GENERAL DYNAMICS

46-6-4 Convair (Was Service Note 3 of AD-2-571-2.) Applies Only to BT-13 Series Airplanes Equipped With a Propeller Spinner.

FIGURE 1

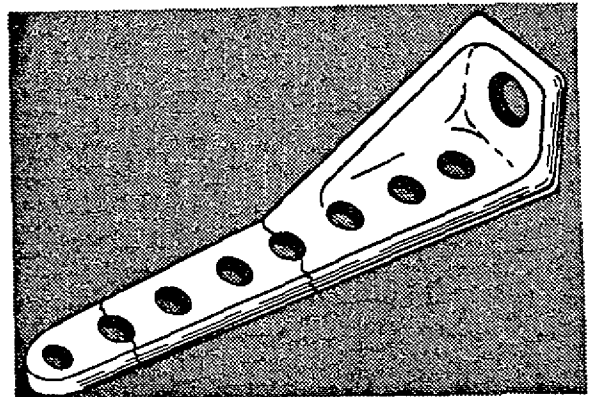
When it has been determined that the rear spar to center section attachment fittings are bronze castings, compliance with this Airworthiness Directive should be effected every 24 hours flying time or every 6 months non-flying time, whichever occurs first.

(1) Inspect visually the rear spar to center section attachment fittings on both sides of the rear spar for evidence of cracks. All cracked fittings (see Figure 1) should be replaced with new fittings of equivalent or greater strength.

(2) A magnet may be used to determine if the fitting is a steel casting.
